FILE NO. A-5/22

TOWNSHIP OF McNAB/BRAESIDE
COMMITTEE OF ADJUSTMENT

NOTICE OF PUBLIC HEARING
APPLICATION FOR MINOR VARIANCE

**Development & Property Department
MINOR VARIANCE PLANNING REPORT
TO THE COUNCIL OF THE
TOWNSHIP OF McNAB/BRAESIDE**

1 SITE PLAN
1/8" = 1'-0"

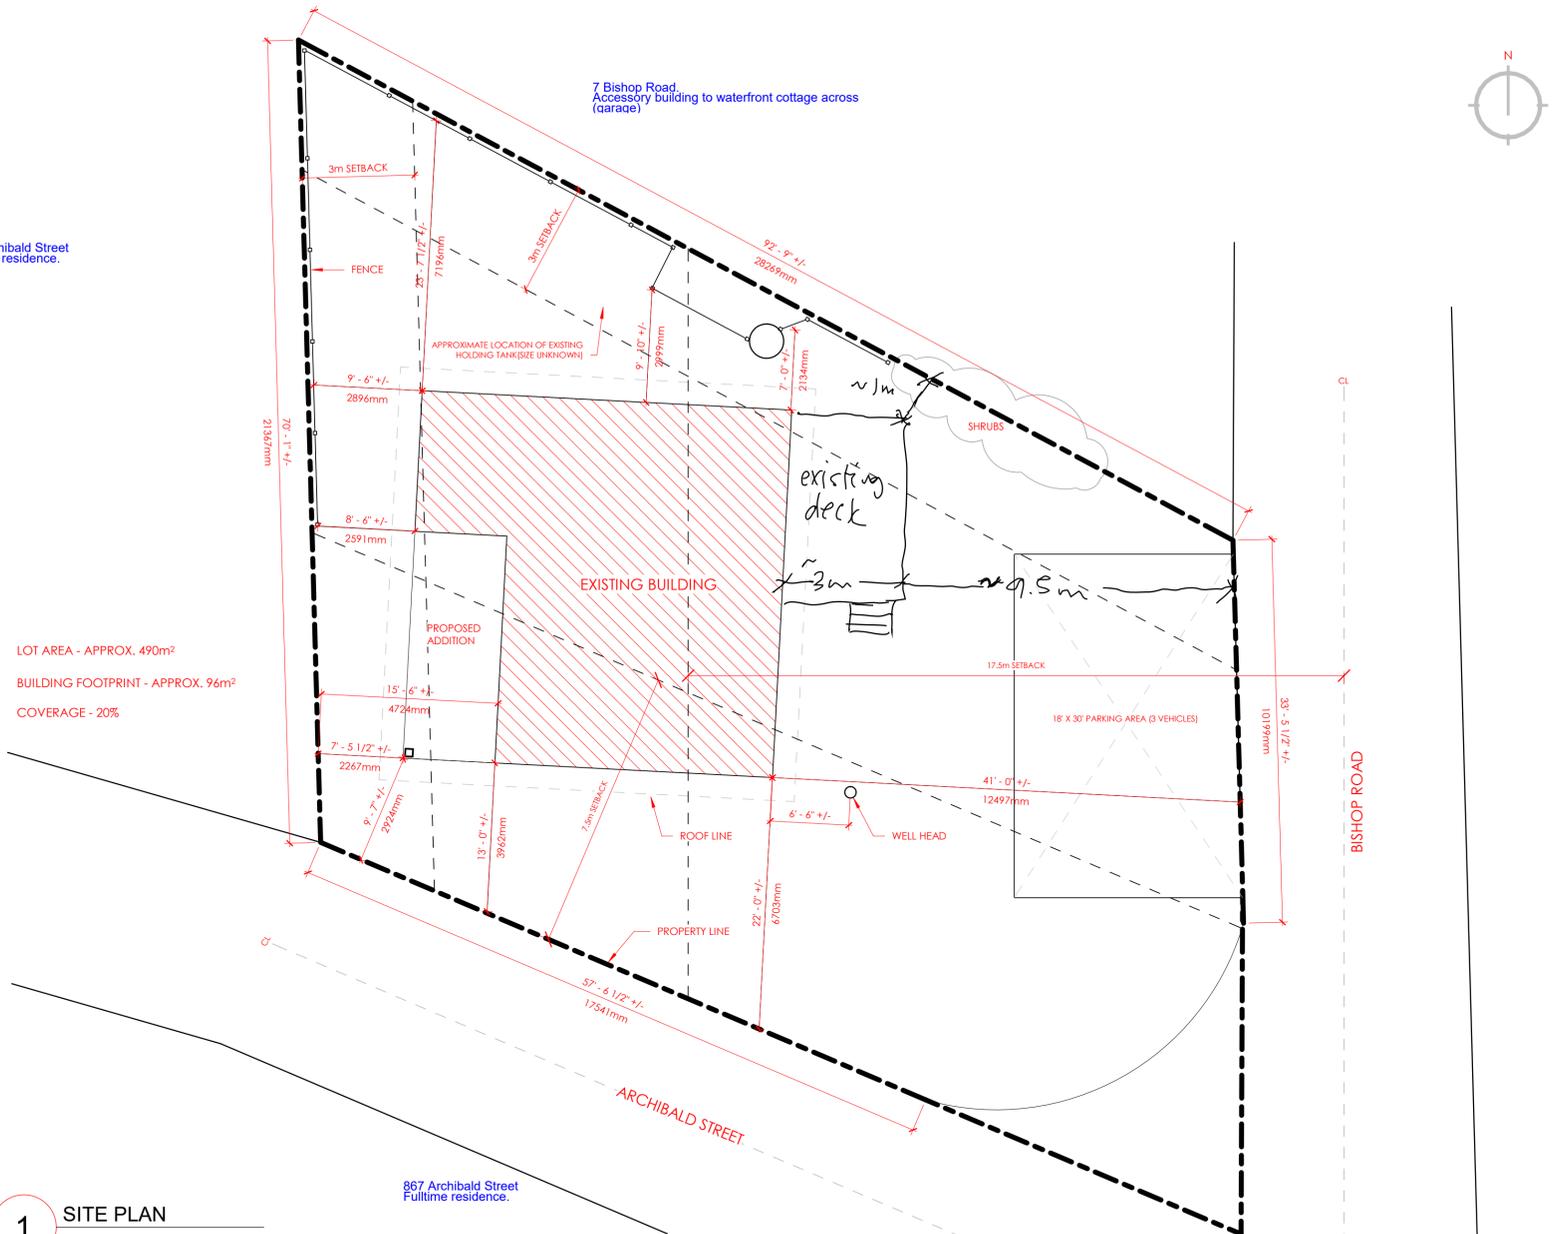
The existing one-storey dwelling is situated slightly to the rear of the lot. Currently, the existing dwelling meets the minimum required setbacks for the front lot line only. The well is located in the front yard, east of the existing dwelling, and the holding tank is located in the interior side yard, to the north of the dwelling. The proposed addition is to the rear of the dwelling, which will further reduce the rear yard setback (currently 2.5 metres, to 2.2 metres). The proposed addition would further reduce the exterior side yard setback also (currently 3.9 metres, to 2.9 metres).

The proposed deck will not further encroach on the front lot line setback, however the encroachment will not increase from what was previously existing (deck has been demolished). The proposed deck will project 3 metres to the interior side yard. This contravenes Section 3.8(c), which permits an encroachment of 2 metres into the *front or rear yard only* for a deck. This would completely reduce the interior side yard setback.

The layout of the deck has raised some concern from a neighbouring property owner. The deck has been proposed to abut the interior side lot line, which is another irregularly shaped lot containing a detached garage. The adjacent property owner opposed the interior side yard setback reduction to 0 metres, maintaining that they would appreciate some distance between the deck and the property line. Additionally, the existing shrub, which is used as a barrier between the lots, would have to be removed to accommodate the deck in its proposed location which the complainant discouraged.

Comments from the Township's Chief Building Official highlighted the requirement of a Registered Plan of Survey to confirm the setback distances from Township and neighbouring properties. Due to the potential for flooding from the Ottawa River in Rhoddy's Bay, the CBO also requested that the survey depict the elevations for floodplains.

Township Public Works concurred with the request for a registered survey to show the property boundaries and the setbacks to existing and proposed structures. A complete entrance permit will be required if there are any changes to the entrance to the property. Additionally, there were concerns raised about the proposed landscaping along Archibald Road. The plantings and large landscape rocks as shown in the sketch must conform to the Township's Property Standards By-law, and be located a minimum of 3 metres from the travelled lane (Section 2.2.3). Consideration

should be had for the height of the landscaping features at the intersection of Archibald Street and Bishop Road as per the regulations for the sight triangle under Section 3.30 – Visibility at Intersections.

That the minor variance be refused to reduce the minimum required interior side yard setback from 3 metres to 0 metres to permit the construction of a new deck. Due to the fact that the property is undersized and irregularly shaped, it is recommended that committee consider a reduced setback to 1.5 metres instead of 0 metres. A 1.5 metre setback will provide additional relief and a slightly larger deck than the existing by-law requires, but will still provide some buffer for the adjacent property owner, allow vegetation to exist and act as a buffer between the properties, and allow for access and long-term maintenance of the deck without trespassing on neighbouring property.

- a) A reduction of the minimum rear yard setback from 7.5 metres to 2.2 metres to accommodate an addition to the existing dwelling;
- b) A reduction to the minimum required exterior side yard setback from 7.5 metres to 2.9 metres to accommodate an addition to the existing dwelling;
- c) A reduction to the minimum setback to the road centerline from 17.5 m to 12.5 metres to accommodate a new deck;
- d) A reduction to the interior side yard setback to 1.5 metres to accommodate a new deck.

- a) That an elevation survey depicting the Ottawa River Floodplain be provided to the satisfaction of the Township Chief Building Official, and further that the survey depict the building setbacks (proposed and existing structures) to the property line;
- b) That the development be floodproofed in accordance with the Building Code and the Township's zoning by-law requirements;
- c) That an application for an entrance permit be submitted to the Township if changes are proposed to the existing access/driveway;

- d) Landscaping and rocks shown on the plan are required to meet the Townships property standards by-law and be setback a minimum of 3 metres from the travelled portion of the road;
- e) That any vegetation/shrubs removed from the interior side yard setback be protected where possible. Where vegetation/shrubs is required to be removed as a result of construction, the owner agrees to replace/plant replacement vegetation after the construction of the deck.
- f) That the proposal be substantially constructed in accordance with the sketch provided with the minor variance application with the exception of the deck setback to the interior lot line.
